# UNITED STATES PATENT AND TRADEMARK OFFICE

APPLICATION NO.	FILING DATE	FIRST NAMED INVENTOR	ATTORNEY DOCKET NO.	CONFIRMATION NO.
09/940,949	08/28/2001	Luc Tripod	PU010180	5192

# Office Action Summary

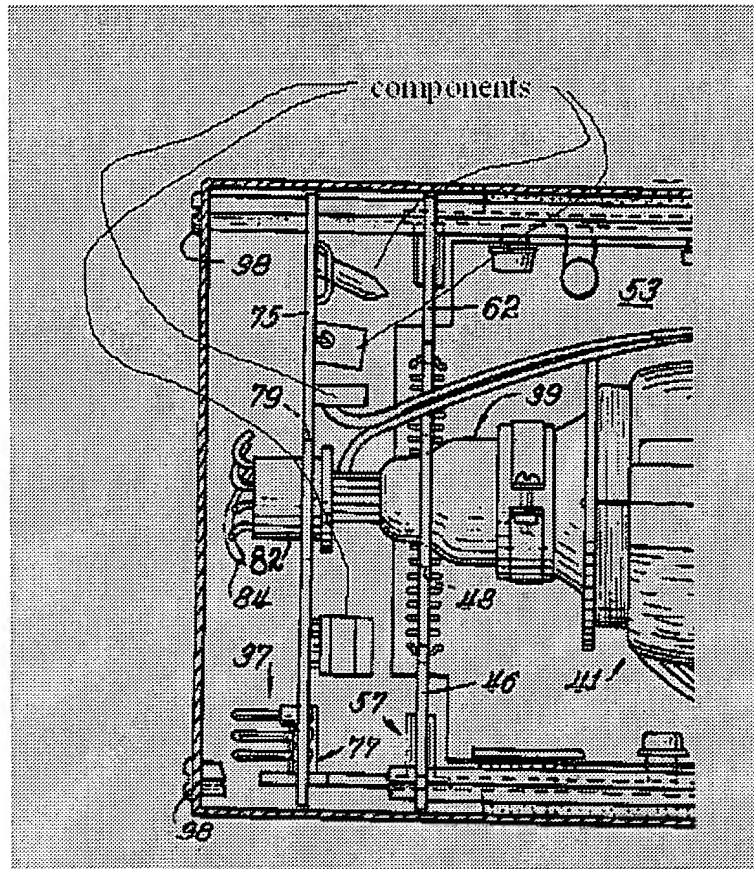
-- In reference to claims 2 and 8, Puhak shows substantially the invention as claimed. However, Puhak does not show the circuit board has a plurality of components mounted thereon, none of the components extending away from the funnel further than the back cover of the socket.

Johnson shows (cover sheet) the circuit board 75 has a four (a plurality) components (see examiner's figure) mounted thereon, none of the four components extending away from the funnel further than the back cover of the socket.

It would have been obvious to one of ordinary skill in the art at the time the invention was made to use the component configuration shown by Johnson on the circuit board of Puhak because, as shown by Johnson (cover sheet), if the components were mounted on the other side of the circuit board, it would not make it possible to use wire 86 to electrically connect at least one of the plurality of components to the funnel.

-- In reference to claim 3, Puhak as modified by Johnson shows (figure 8 ) the circuit board has a plurality of components (see examiner's figure) mounted on the first side.
